**Board of Zoning Appeals Meeting
June 18, 2024**

CASE NUMBER:	V-24-0004
PROPERTY LOCATION:	9825 Autry Falls Drive, Johns Creek, GA 30022
CURRENT ZONING:	R-4A (Single Family Dwelling District) Conditional
PARCEL SIZE:	11.70 Acres
PROPERTY OWNER:	The Falls of Autry Mill Homeowners Association Inc.
VARIANCE REQUEST:	Encroachment into the 75-foot stream buffer for bank stabilization, restoration of the lakefront common area and to construct a 6-foot-wide pedestrian walkway
STAFF RECOMMENDATION:	APPROVAL WITH CONDITIONS

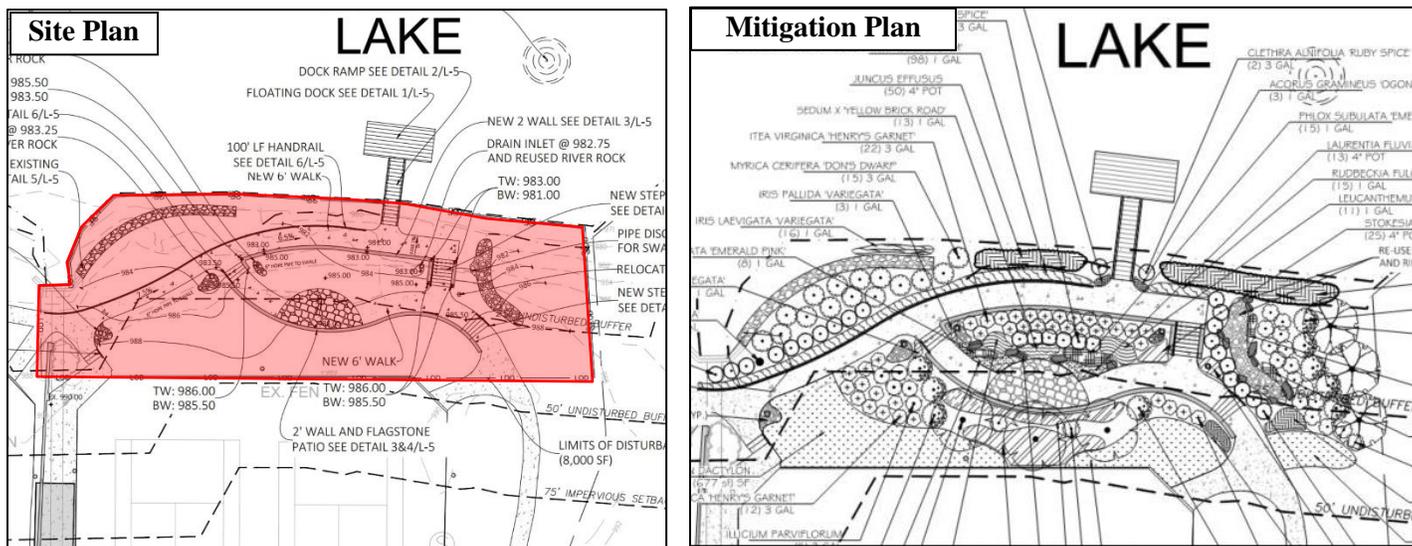
As part of the lakeshore restoration and bank stabilization project, the Applicant proposes the removal of several rock walls, stone walls and a portion of the existing sidewalk to rebuild the area with a flagstone patio surrounded by a 2-foot-tall wall and a 6-foot-wide pedestrian pathway. Several of the existing river rocks would be reused to help with drainage of the current site and a 2.5-foot-tall gabion wall would also be constructed to help stabilize the bank. The entire project will be contained within the City's 50-foot stream buffer.

Within the project area, the Applicant is proposing a total impervious surface of 2,158, which includes 1,342 square feet of existing impervious and an addition of 816 square feet of new impervious surface. The total disturbance within the 50-foot stream buffer, bounded by the limits of disturbance, is 8,000 square feet (shown in red on the following page).

- 1) The proposed development shall not exceed the following encroachments, as shown on the site plan received by the Community Development Department on May 7, 2024:
 - a. 8,000 square feet of new disturbance within the stream buffer.
 - b. 2,158 square feet of total impervious surface, which includes 816 square feet of net new impervious surface within the stream buffer.
- 2) A vegetative planting plan shall be submitted to the Community Development Department, as part of the Minor Land Disturbance Permit. Said plan shall be consistent with the mitigation plan received by the Community Development Department on May 7, 2024. The final vegetative planting shall pass City inspection prior to the closeout of the Minor Land Disturbance Permit.
